APPLICATION NO.	FILING DATE	FIRST NAMED INVENTOR	ATTORNEY DOCKET NO.	CONFIRMATION NO.
10/660,067	09/11/2003	Bart De Laender	40987	6186

Office Action Summary	Application No. 10/660,067	Applicant(s) LAENDER ET AL.	
	Examiner Janet M. Wilkens	Art Unit 3637

FIG 1

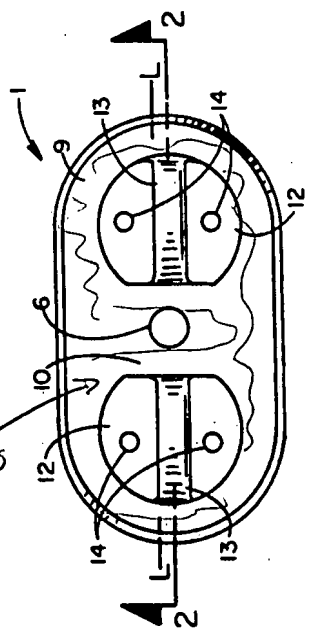
Addressing the art rejections over Ausavich: as stated above, limitations found in intended use/"for" statements are given no weight in the claims. Therefore, much of what is stated in claims 64 and 82 are not being considered as positively claimed. Furthermore, it is contended that the blocks of Ausavich do have upper and lower surface portions devoid of any openings (see Attachment A). Note: there is nothing in the claims that says that the entirety of the upper and lower surfaces are completely devoid of openings. Also, the fasteners being inserted into these portions are not being positively claimed as such.

no openings

FIG 2

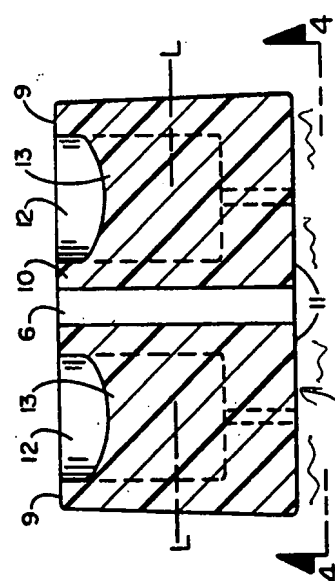
no openings
